Aqueous Solutions (owner) AQS-MFG-OIL_FRAC-NOZZLE_ORIENT
OIL_FRAC fabrication drawing NOZZLE_ORIENT (AQS-PLAN-006 M3;
Type: fabrication drawing (GA / nozzle orientation / part sheet) Rev b44fbb91 Issued
Created: flow graph pipeline Approved: not approved (study)
Sheet 1 of 1 AQS-DWG-001

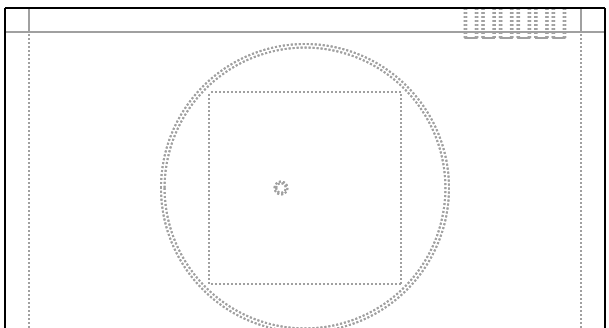
Graph revision AD - nozzle_orient: 14 schedule rows of docs-authority/nozzles/OIL_FRAC.csv at tag, face and bore - the issued schedule replaces the style-buil
Graph revision AD - nozzle_orient: Inlets N1-N4, N12, N14 on -Y at z 160 (N14 solids row drawn DN15 bore not calculated per plan W4); outlets N5-N8 (the fou
Graph revision AD - nozzle_orient: N9 drain flush at the envelope bottom (50 datum); N10 vent flush at the envelo
Graph revision AD - nozzle_orient: Atmospheric open-bore tube stubs per duty section 4 (nozzle DN15, no flange cl
